LIGHTS - LED TAIL STROBE LIGHT INSTALLATION

The original tail nav/strobe light is no longer available. A new LED tail nav/strobe light is available as a replacement.

MTB-33-03  
Page 1 of 15

Figure 1. Before Modification (Sheet 1)

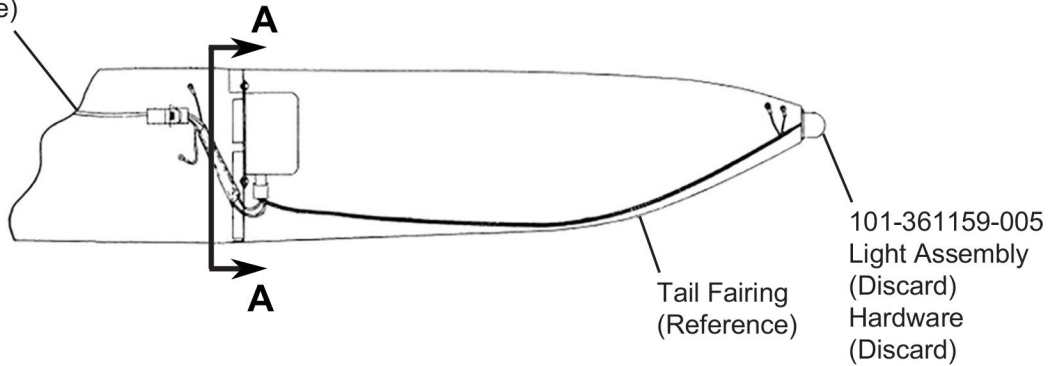
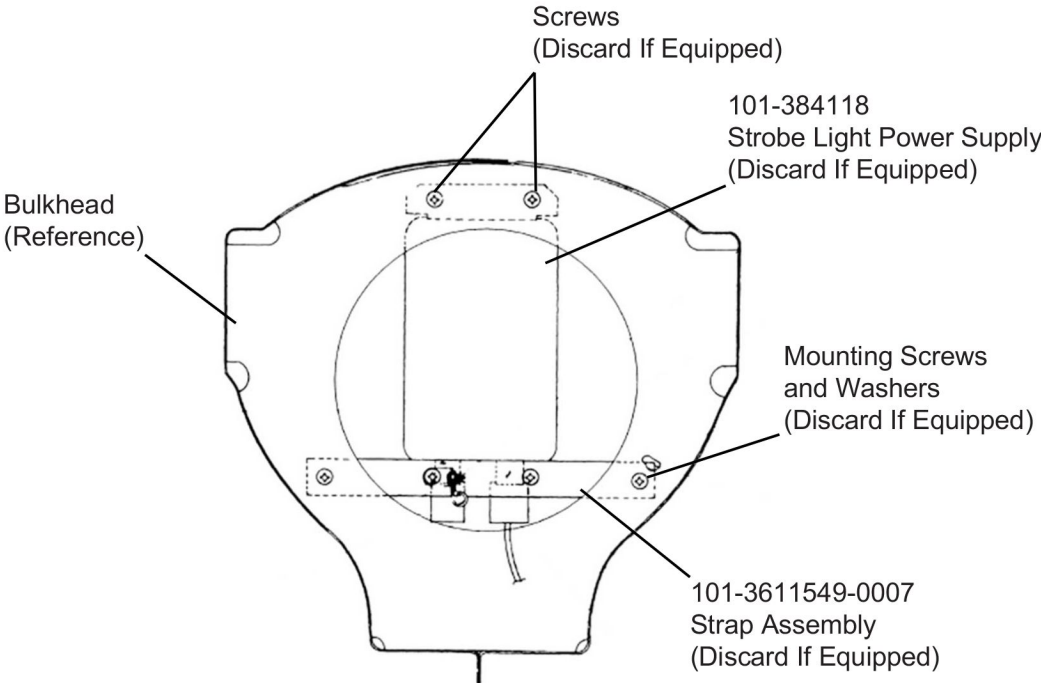
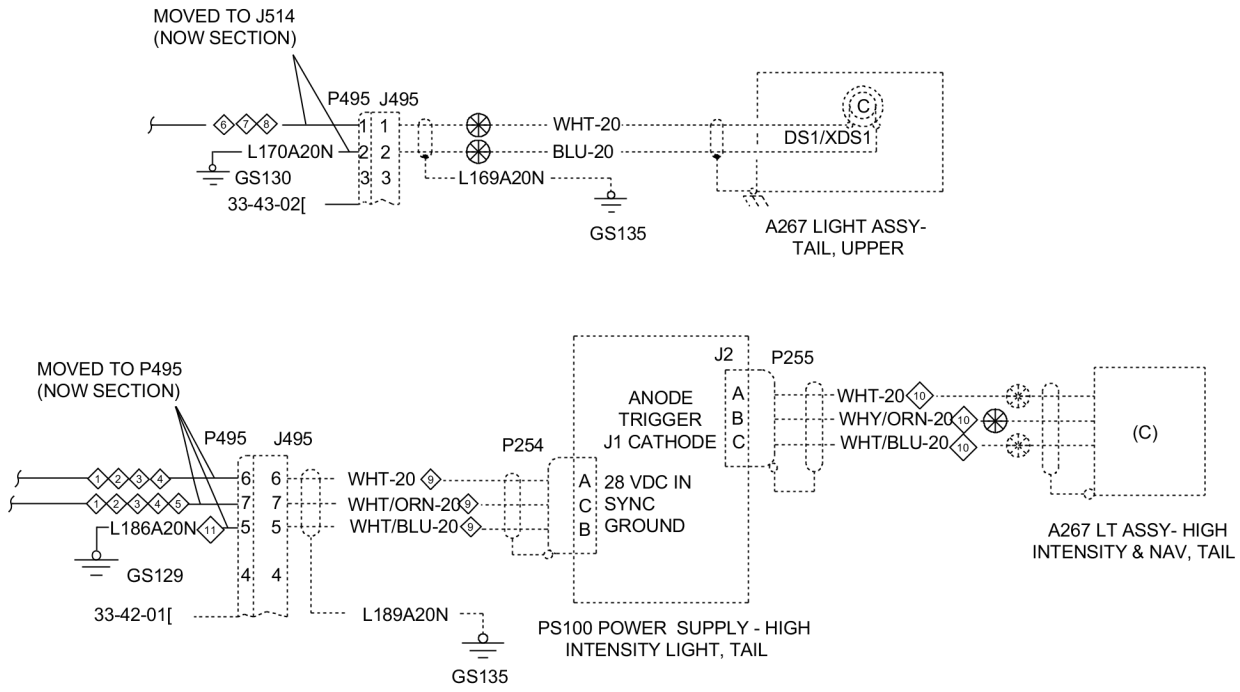
- D. Remove the aft tail fairing.
3. (Refer to Figure 1, Sheets 1 and 2.) Remove the aft tail strobe light assembly and wiring as follows:
  - A. Airplanes equipped with a 101-384118 Strobe Light Power Supply, go to Step 3 C.

- B. Airplanes not equipped with a 101-384118 Strobe Light Power Supply, go to Step 3 F.
  - C. Remove and discard the four screws that attach the 101-384118 Strobe Light Power Supply.

- D. Remove and discard the two mounting screws and washers that attach 101-3611549-0007 Strap Assembly to the bulkhead.
  - E. Discard the 101-3611549-0007 Strap Assembly.

- F. Remove and discard the hardware that attaches the 101-361159-005 Light Assembly to the tail fairing.
  - G. Discard the 101-361159-005 Light Assembly and the associated harness.

Figure 2. Wiring Modifications (Sheet 1)

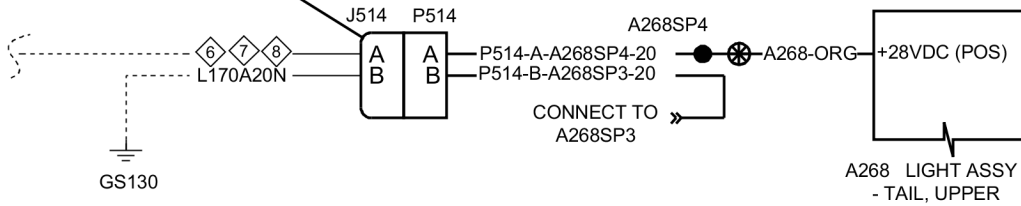
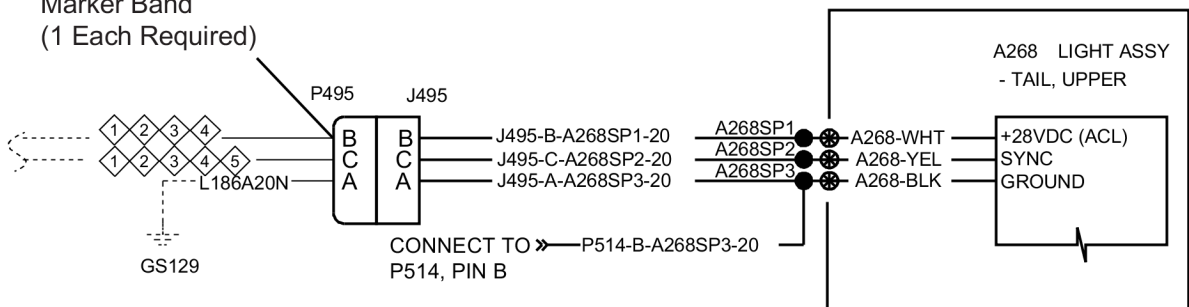
4. (Refer to Figure 2, Sheets 1, 2, and 3.) Do the wiring modification to the airplane wiring harness as follows:
  - A. Remove and discard the P495 Connector.

- B. Install a SJS840400 Pin Receptacle two M39029/58-364 Contact Pins and two MS27488-16 Sealing Plugs onto the existing airplane wiring harness.
  - C. Install a SJS840410 Pin Plug with three M39029/57-358 Sockets and one MS27488-16 Sealing Plug onto the existing airplane wiring harness.

- D. Install and label each connector using one 131741-3 Marker Band onto the airplane wiring harness.
5. (Refer to Figure 3, Sheets 1 and 2.) Install the 130-366006-0001 Strobe Light and Wiring Harness Assembly as follows:

Figure 3. After Modification (Sheet 1)

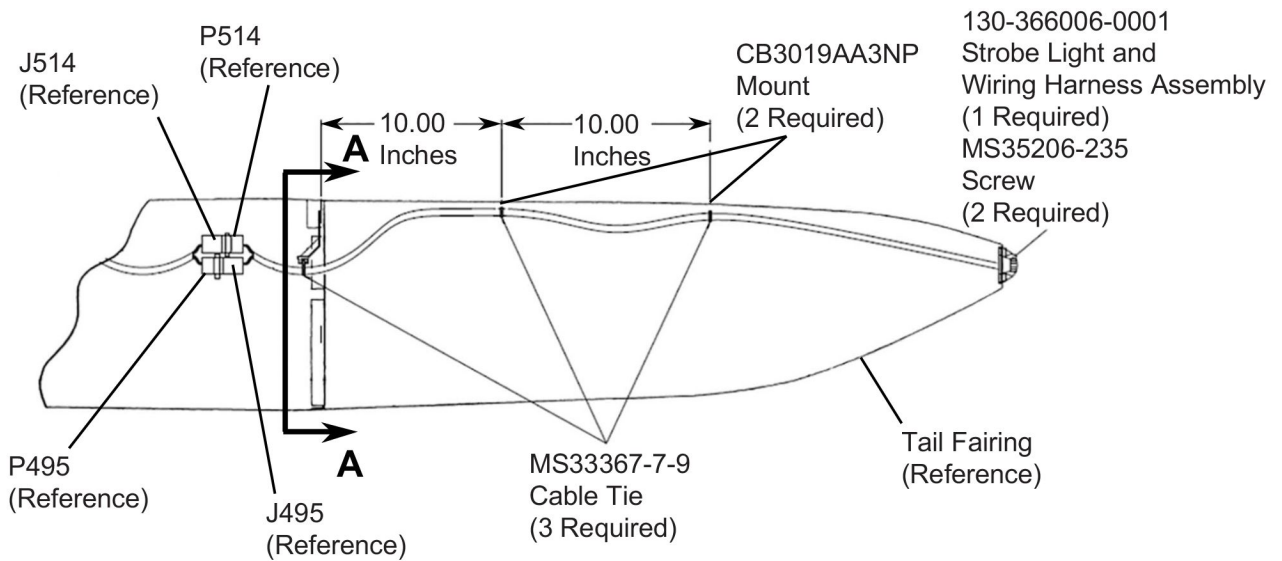
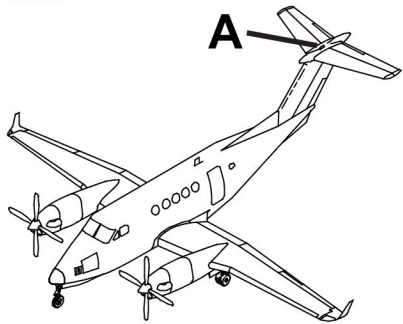
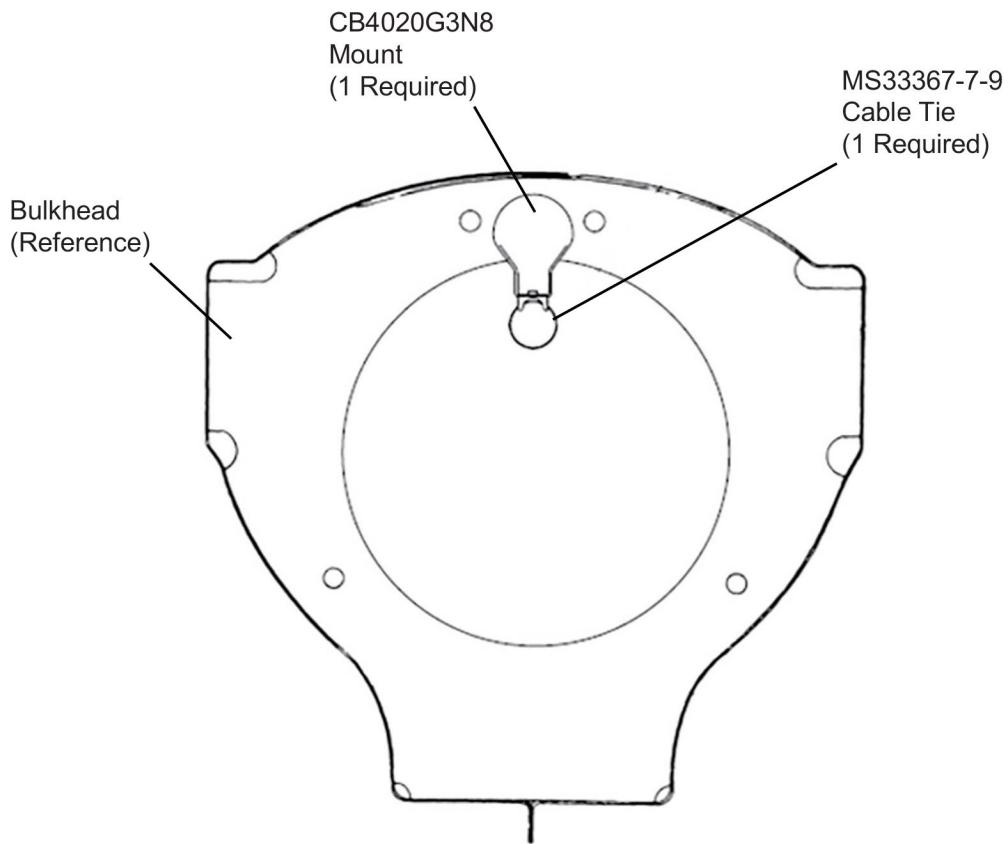
- A. Apply EA9309 Adhesive to the two CB3019AA3NP Mounts.
  - B. Install the two CB3019AA3NP Mounts onto the upper surface of the tail fairing approximately 10.0 inches from the bulkhead and from each other.

- C. Apply EA9309 Adhesive to the CB4020G3N8 Mount and install the CB4020G3N8 Mount to the forward side of the bulkhead in the tail fairing.
    - (1) Make sure the EA9309 Adhesive has had time to cure.

- D. Install the wiring harness of the 130-366006-0001 Strobe Light and Wiring Harness Assembly from the aft end of the tail fairing.
  - E. Electrically bond the 130-366006-0001 Strobe Light and Wiring Harness Assembly to the aft end of the tail fairing.

- (1) Apply adequate U470638 Sealant between the 130-366006-0001 Strobe Light and Wiring Harness Assembly and tail fairing.

**NOTE:** The U470638 Sealant should squeeze out when the two MS35206-235 Screws are installed.
    - (2) Install two MS35206-235 Screws through the 130-366006-0001 Strobe Light and Wiring Harness Assembly and the tail fairing.
    - (3) Make sure to clean off access sealant between the 130-366006-0001 Strobe Light and Wiring Harness Assembly and the tail fairing with Isopropyl Alcohol.
    - (4) Make sure that the electrical bond is no more than 0.01 Ohms.
  - F. Attach the wiring harness from the 130-366006-0001 Strobe Light and Wiring Harness Assembly with one MS3367-7-9 Cable Tie to each of the mounts that were attached to the tail fairing and bulkhead.
  - G. Install the tail fairing.
